Office Action Summary

10/516,571

KONDO ET AL.

DETAILED ACTION

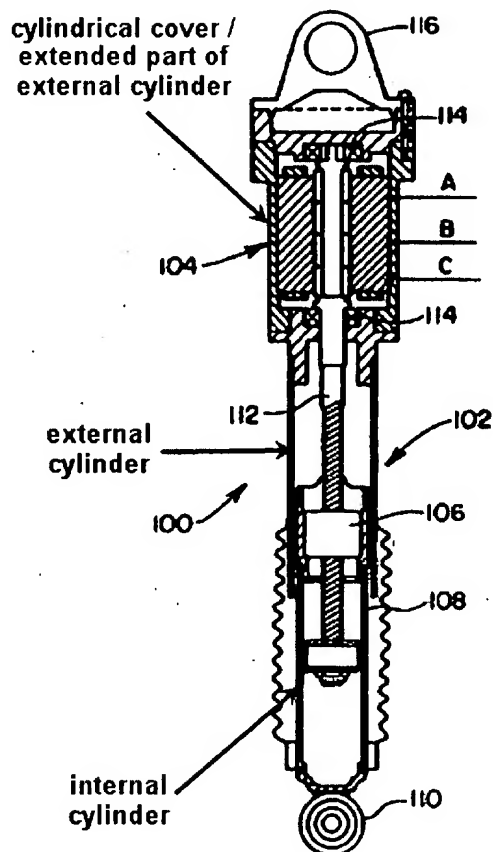
Regarding **claim 1**, Patil et al. disclose an electromagnetic shock absorber comprising: a shock absorber body (100) which makes telescopic motion in response to an input from outside; a ball screw mechanism (102) which is arranged at the shock absorber body (100), converts the telescopic motion into rotary motion (column 5, lines 1-10), and is composed of a ball nut (106) and a screw shaft (112); a motor (104) which is provided coaxially with the shock absorber body (100) and generates electromagnetic resistance to oppose against the rotary motion to be input into a rotary shaft (carried by upper end of screw shaft 112; column 5, lines 11-24) of the motor (104); and a cylindrical member which covers the shock absorber body (100) and the motor (104) from outside and whose part to cover the motor (104) also serves as a motor frame (Fig. 1); **[claim 2]** the shock absorber body (100) has an external cylinder and an internal cylinder to be slidably inserted into the external cylinder; a cylindrical cover having the frame of the motor (104) is coaxially connected with an upper part of the external cylinder; and the external cylinder and the cover constitute the cylindrical member (see figure below); **[claim 3]** the shock absorber body (100) has an external cylinder and an internal cylinder to be slidably inserted into the external cylinder; an upper part of the external cylinder extends so as to cover the motor (104) and the frame of the motor (104) is formed at an extended part of the external cylinder; and the cylindrical member is constituted by the external cylinder (see figure below); **[claims 4 and 7]** the rotary shaft (carried by upper end of screw shaft 112) of the motor (104) is

rotatably supported at its both ends by a pair of bearings (114) installed at the external cylinder.

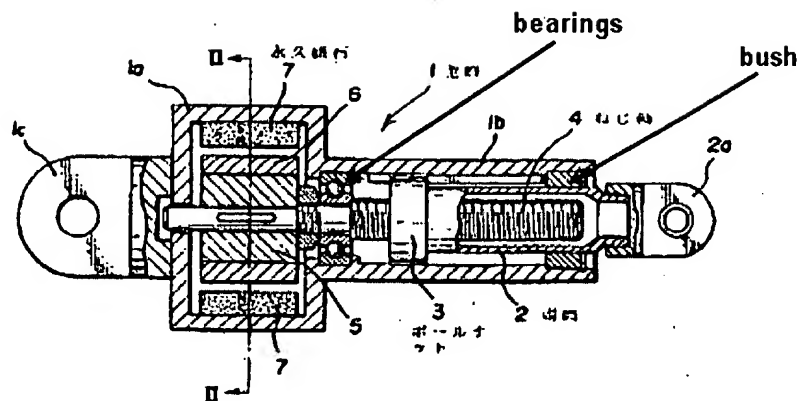
Kazuo discloses in Figs. 1 and 3 a damper comprising an internal cylinder (2) slidably supported by a bush at the lower end of an external cylinder (1b). Kazuo also discloses a screw shaft (4) rotatably supported through bearings installed inside the external cylinder (1b). See figure below.

At the time of the invention, it would have been obvious to a person of ordinary skill in the art to use a bush and bearings as taught by Kazuo within the electromagnetic shock absorber of Patil et al. The suggestion/motivation for doing so would have been to provide better alignment and support between the internal and external cylinders as well as the screw shaft and the external cylinder, which facilitates proper functioning of the shock absorber.
